Updating the antenna location

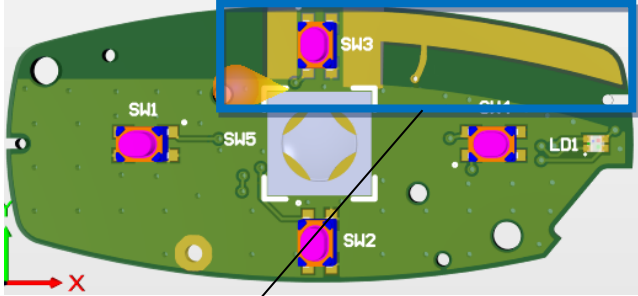
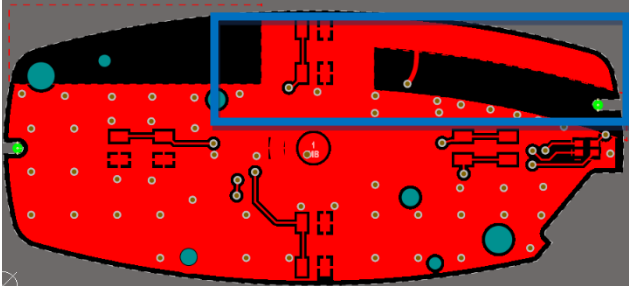
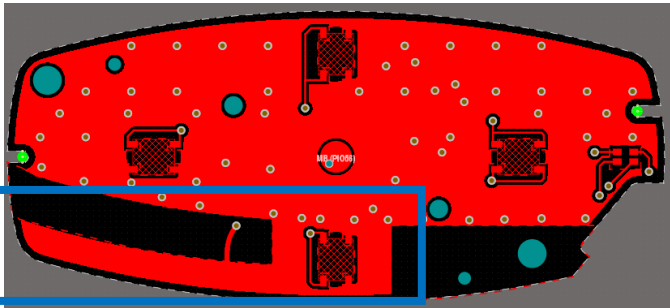
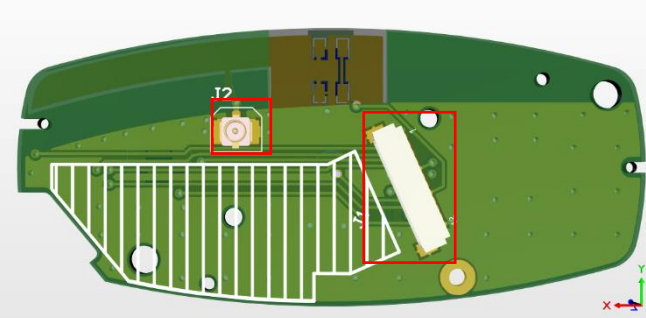
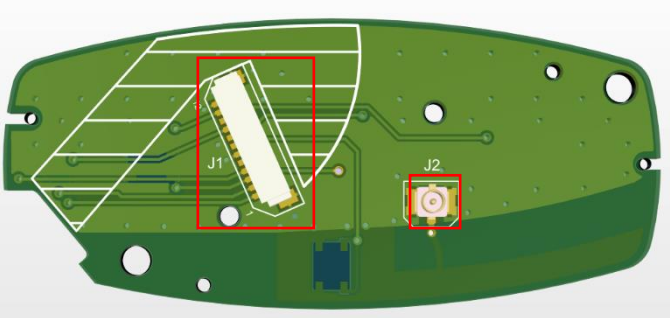
The are no differences between the antenna, the same pattern, the only change is the position of the antenna.
